Re: 49 CFR Parts 567, 571, 574 and 575
Docket Number NHTSA-01-11157
Tire Safety Information
Notice of Proposed Rulemaking (NPRM)

Comments of the
RUBBER MANUFACTURERS ASSOCIATION

Notice of Proposed Rulemaking
Tire Safety Information
49 CFR Parts 567, 571, 574 and 575
Docket No. NHTSA-01-11157

Figures 1 and 2

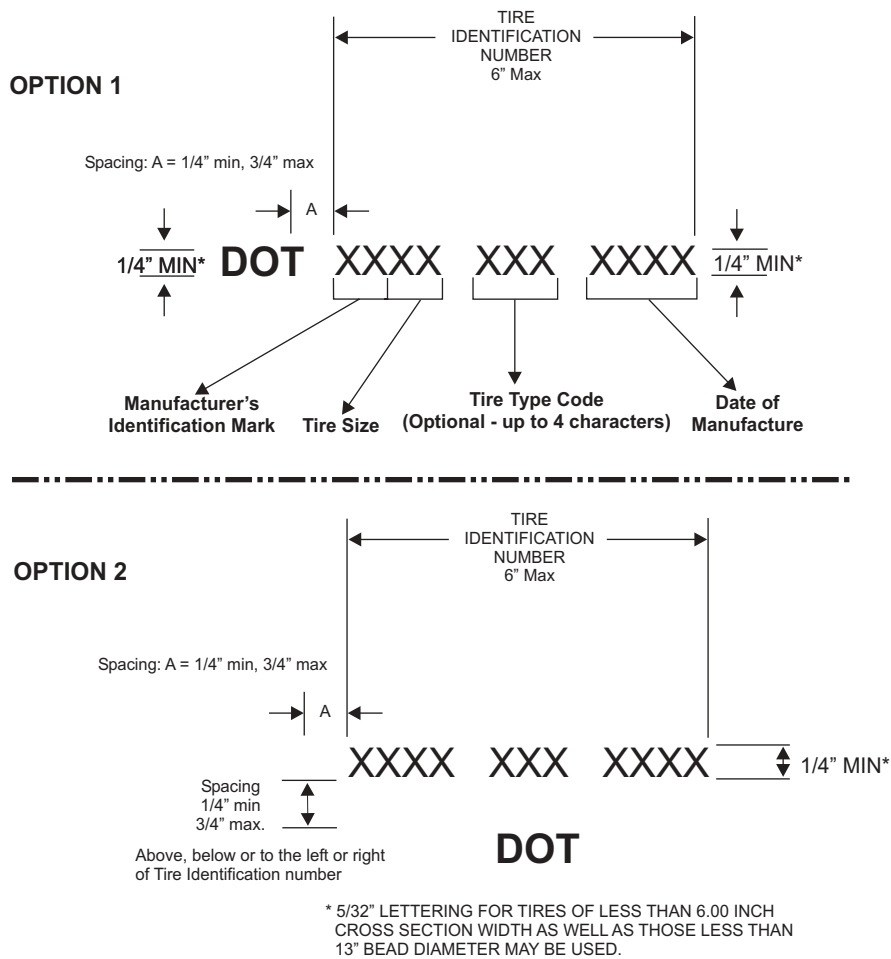
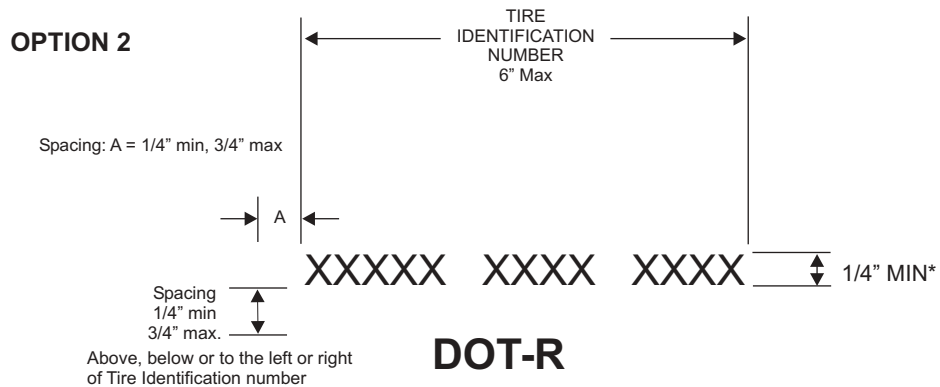
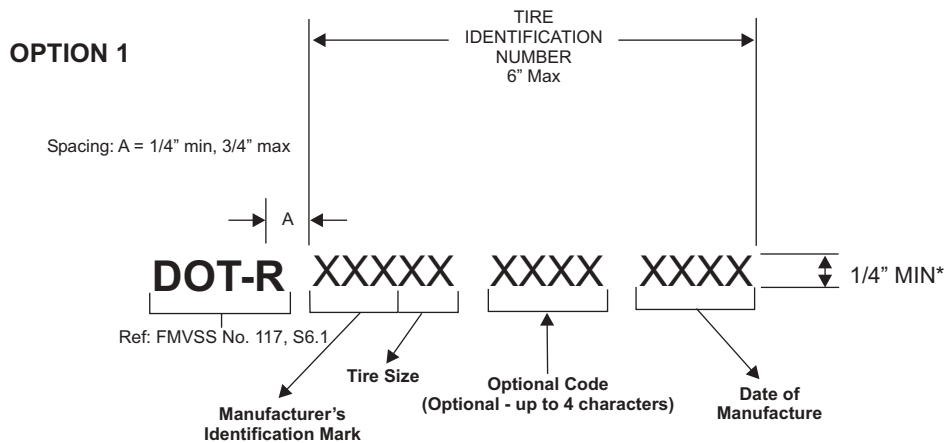
In Figures 1 and 2 (see 66 Fed. Reg. pages 65565 and 65566), the agency does not show any tolerance on the ¼ inch character height or any dimensions on the spaces shown between groupings of characters in the TIN. The agency states, “a requirement for a uniform TIN font size would significantly improve the readability of the TIN”. The ¼ inch should be a minimum height. The TIN should be located in close proximity to the DOT symbol, with a 6-inch maximum spacing width for the tire identification number specified.

*We would also like to point out an apparent unintended omission to the material found in Figures 1 and 2. Until 1999, the ¼ inch minimum height dimension contained an asterisk that referred to the following statement: “*Use 5/32 inch lettering for tires of less than 6.00 inch cross-section width as well as those less than 13-inch bead diameter.” In the Thursday, July 8, 1999, Federal Register, Final Rule announcement (49 CFR Part 574, docket number 99-5928) changing the date code from a three to a four-digit number, the revised Figures 1 and 2 did not contain the asterisk or the statement. This is certainly an inadvertent change and while it does not affect the labeling of the great majority of light vehicle tires, we call the agency’s attention to it in order to correct the oversight. The oversight does have a large impact on motorcycle tires.*

Proposed revisions to Figures 1 and 2, with the suggested changes cited in the above two paragraphs are shown in **Attachment IV**.

With restored inadvertent omission of statement:

“* Use 5/32” lettering for tires of less than 6.00 inch cross section width as well as those less than 13 inch bead diameter.”

* 5/32" LETTERING FOR TIRES OF LESS THAN 6.00 INCH
CROSS SECTION WIDTH AS WELL AS THOSE LESS THAN
13" BEAD DIAMETER MAY BE USED.
